Title: **STAGE 1 ROAD SAFETY AUDIT**

**Proposed Mixed Use Development , Swords Road, Santry,
Dublin 9.**

Client: **DBFL Consulting Engineers.**

Date: **July 2021**

3.1 Problem

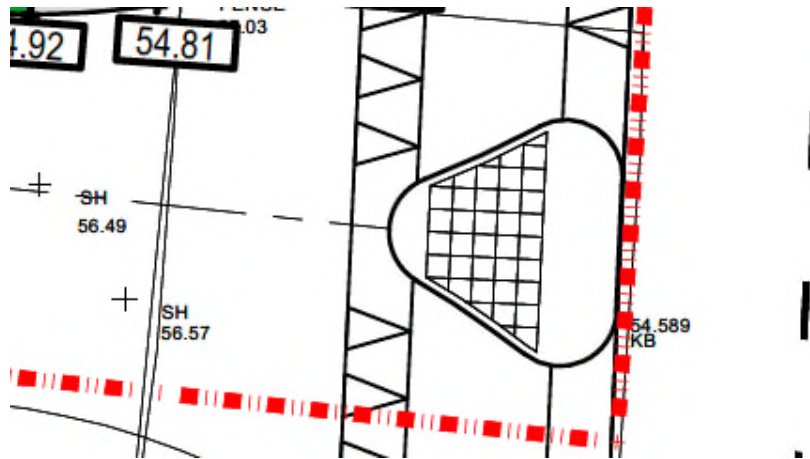
The junction of the access road to the South of the site appears to be a left in-left out junction (confirmed in the Traffic & transport Assessment provided by way of background information). It was observed during the site visit that the junction is not signed as such and drivers are turning right into it. The shape of the splitter island could lead to drivers entering the access road on the wrong side of the splitter island resulting in head-on collisions.

It is recommended that the signage and road markings relating to the left-in left-out only junction be provided or that the splitter island be reconfigured to allow all movements at the junction.

3.1	Yes	No	This junction has already received planning permission under Planning Ref.:2713/17 and is under construction. 'No Right Turn' signs can be facilitated within site boundary. The turn from Swords Road is under the control of the Local Authority and they will be made aware of the potential issue.	Yes

3.2 Problem

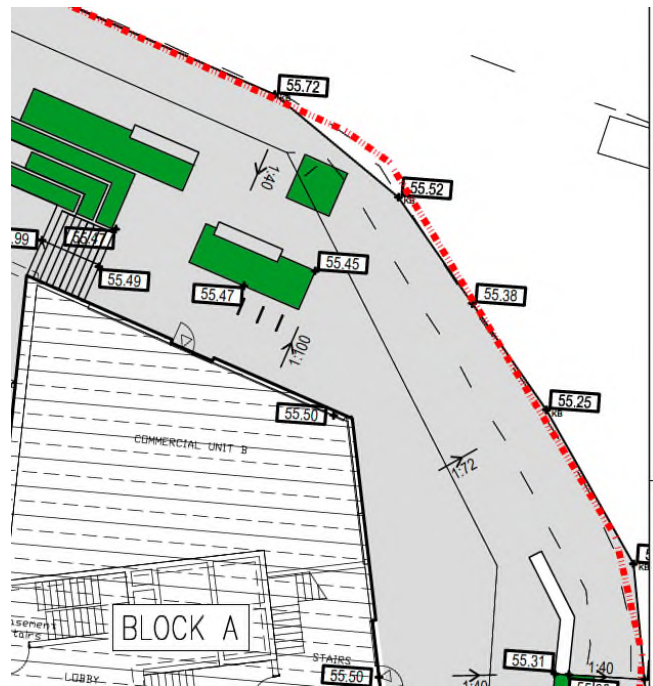
The corner radius of the R132/Santry Avenue junction is very large. This leads to high turning speeds and higher injury severities if pedestrians or cyclists are struck. There will be an increase in pedestrian activity at this junction as a result of the proposed development and there will be a corresponding reduction in heavy goods vehicles due to the replacement of the hardware premises. There is an existing issue with pedestrian collisions in that area as observed from the RSA data.

It is recommended that the corner radius is reduced at the junction.

3.2	Yes	No	This area is outside the site boundary and under the control of the Local Authority. The current footpath layout and radius is under review as part of the "BusConnects" scheme. The "BusConnects" DRAFT plans show a reduction of the radius and a more pedestrian friendly junction.	Yes

3.3 Problem

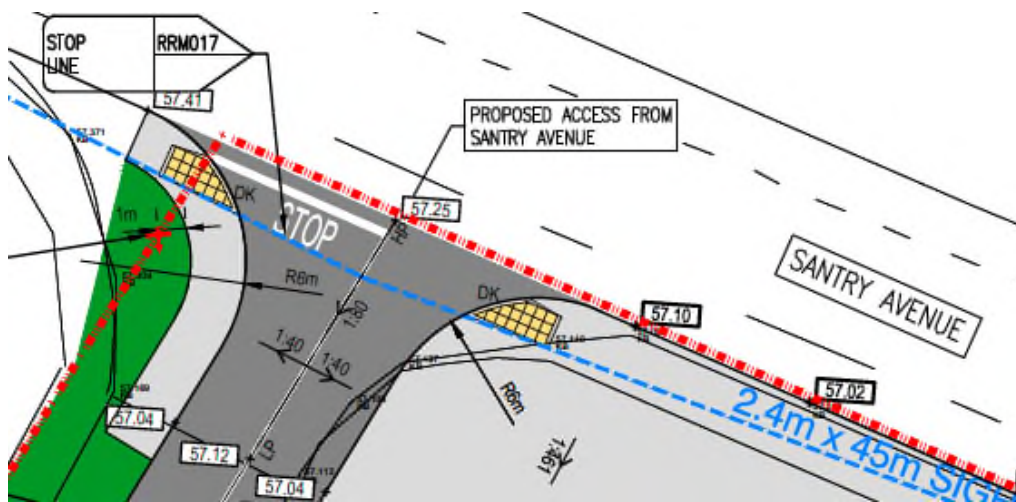
The proposed vehicular access off Santry Avenue is opposite an on-road bus stop (Route 17A) which is currently slightly built-out from the through kerb line. Drivers may exit from the proposed development when other drivers are overtaking parked buses which could lead to head on-or side swipe collisions.

Ensure that the proposed access does not compromise the safety of road users when busses are stopped on Santry Avenue. This may require the relocation of the bus stop.

3.3	Yes	No	Relocation of the bus stop is outside the site boundary and under the control of the Local Authority.	Yes
3.4	Yes	Yes	The recommendation will be incorporated during detailed design stage.

3.4 Problem

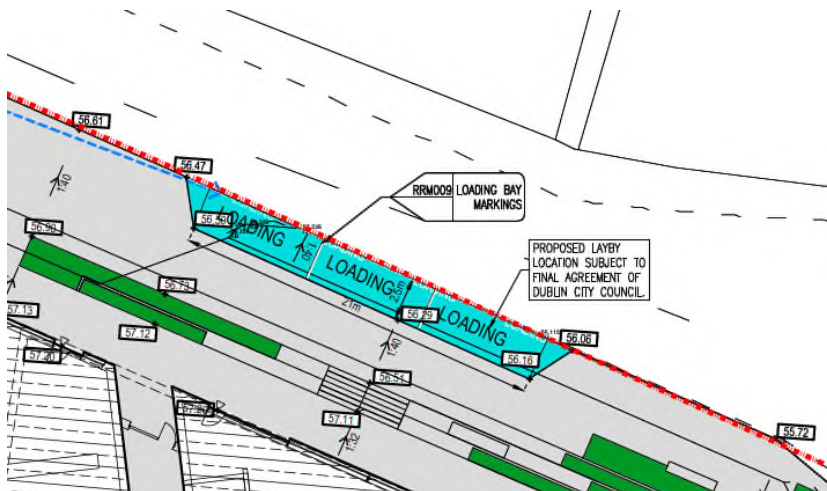
It is proposed to provide 3no. loading bays on Santry Avenue. It is unclear if there are routes for deliveries to the development that do not include steps or excessively long journeys. If the loading bays are not conveniently located there is a risk that delivery drivers may park on the footpaths and be hazards for pedestrians.

It is recommended that the loading bays be placed at convenient at grade locations for deliveries to/from the proposed development.

3.7 Problem

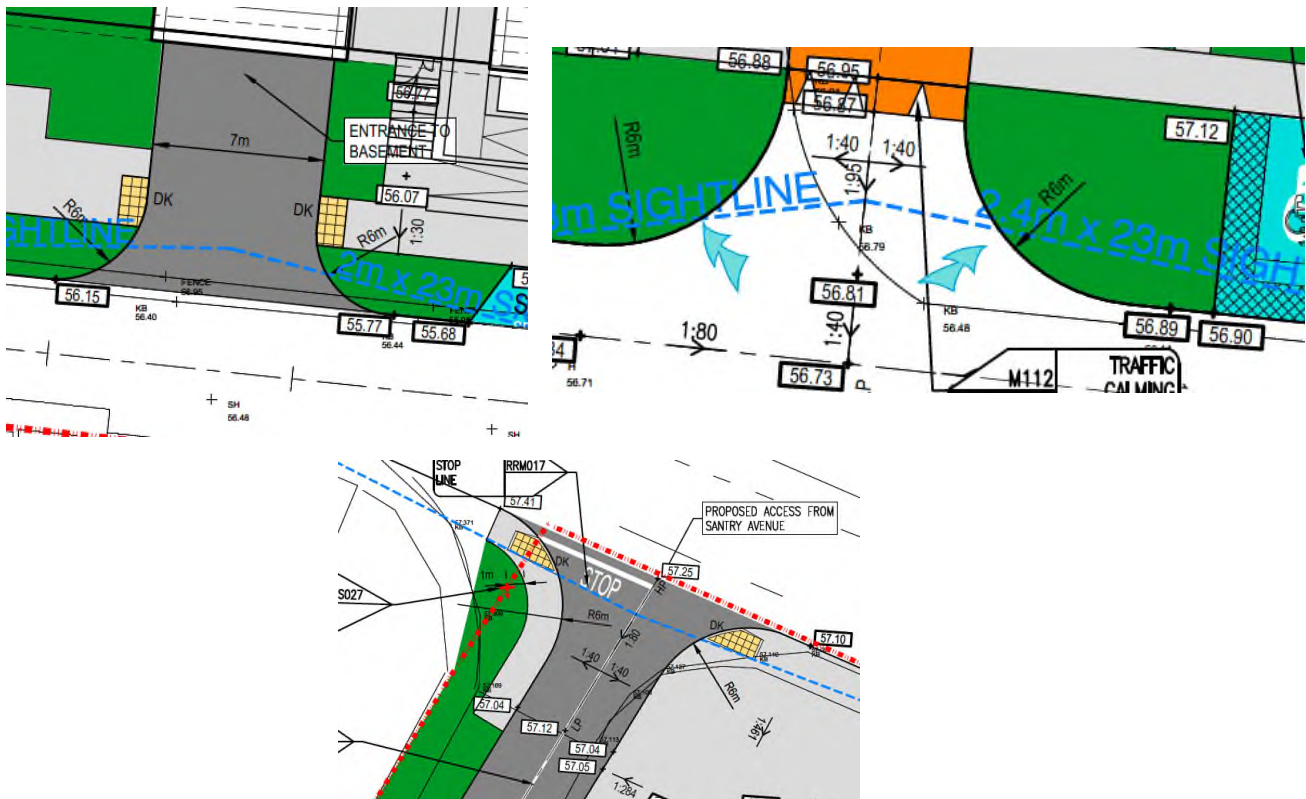
It is proposed to have 6m corner radii at all the vehicular accesses including the basement access. Larger corner radii can lead to higher turning speeds, greater distances for pedestrians to cross and greater likelihood of turning drivers not being able to see cyclists. Larger radii therefore lead to higher likelihoods and severity of collisions with vulnerable road users.

It is recommended that suitable corner radii be provided.

3.5	Yes	Yes		
3.6	Yes	Yes	The recommendation will be incorporated during detailed design stage.	
3.7	Yes	No	These radii are to accommodate larger vehicle (refuse/Fire Tender)	Yes

Paragraph No. in Safety Audit Report	Problem accepted (yes/no)	Recommended measure accepted (yes/no)	Alternative measures (describe)	Alternative measures accepted by Auditors (Yes/No)
			maneuverability and in line with DMURS.	
3.8	Yes	Yes	The recommendation will be incorporated during detailed design stage.

3.8 Problem

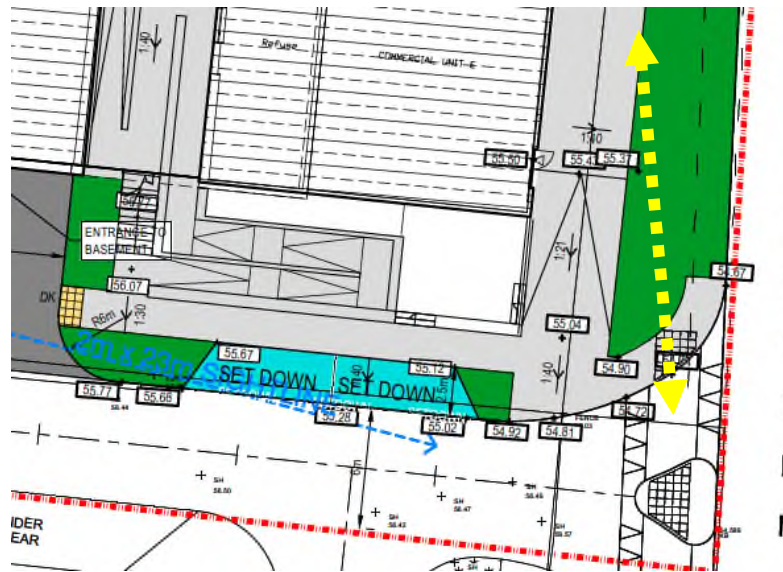
The proposed footpath along the R132 is set back from the kerb line due to the widened grassed verge. The proposed footpath does not align with the crossing at the southern access and is not along the desire line. This could lead to pedestrians not associated with the development travelling on the grassed verge which could lead to slips and falls.

It is recommended that a footpath be provided that caters for the desire line and crossing of the access.
